UNITED STATES PATENT AND TRADEMARK OFFICE

APPLICATION NO.	FILING DATE	FIRST NAMED INVENTOR	ATTORNEY DOCKET NO.	CONFIRMATION NO.
10/776,784	02/11/2004	Manfred Eichenauer	2426.35US01	3227
7590	12/29/2005		EXAMINER	
Douglas J. Christensen Patterson, Thuente, Skaar & Christensen, P.A. 4800 IDS Center, 80 South Eighth Street Minneapolis, MN 55402			LUGO, CARLOS	
			ART UNIT	PAPER NUMBER
			3676

Office Action Summary	Application No.	Applicant(s)
	10/776,784	EICHENAUER, MANFRED
	Examiner Carlos Lugo	Art Unit 3676

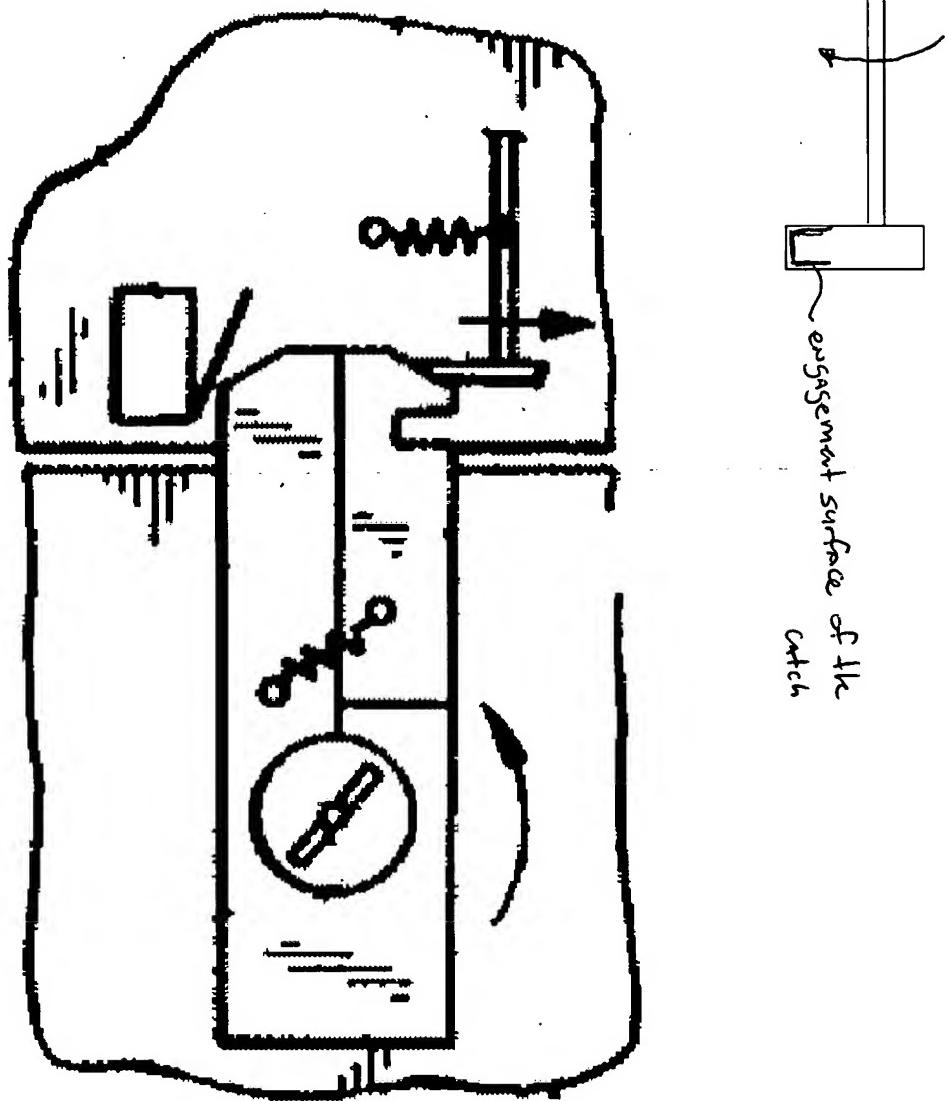
engagement surfaces of the catch are provided on a lateral side of the catch in the direction of its latching pivotization (see attachment #1).

The applicant argues that Kletzmaier fails to disclose the new limitation presented in claim 1 that the engagement surfaces of the catch are provided on a lateral side of the catch in the direction of its latching pivotization. However, as seen in attachment #1, Kletzmaier clearly illustrates that the engagement surfaces of the catch are provided on a lateral side of the catch in the direction of its latching pivotization. Therefore, the argument is not persuasive and the rejection is maintained.

Pivotal movement to latch the catch

engagement surface of the
catch
